MILITARY SPECIFICATION

CIRCUIT CARD ASSEMBLY - THOUSANDS DECADE
MEMORY AND READOUT - A2: 10547220

This amendment forms a part of Military Specification MIL-C-60577(MU) dated 18 June 1970.

FIGURE 2

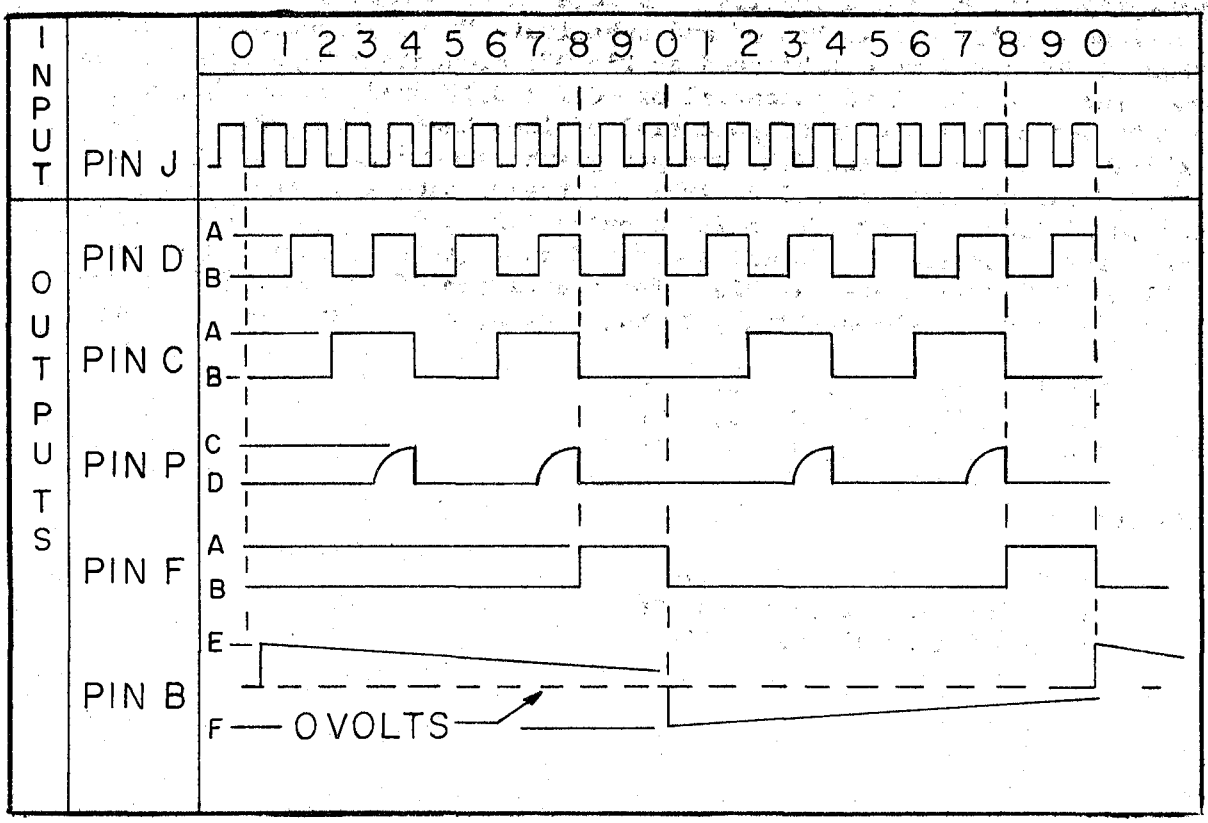
FIGURE 2: Delete in its entirety and substitute:

AMPLITUDES

+70°F	+155°F	-65°F
A	1.0V MIN	.85V MIN	1.2V MIN
B	.21V MAX	.28V MAX	.20V MAX
C	.8V MIN	.8V MIN	.8V MIN
D	.3V MAX	.3V MAX	.3V MAX
E	1.2V MIN	1.2V MIN	1.2V MIN
F	-1.2V MIN	-1.2V MIN	-1.2V MIN
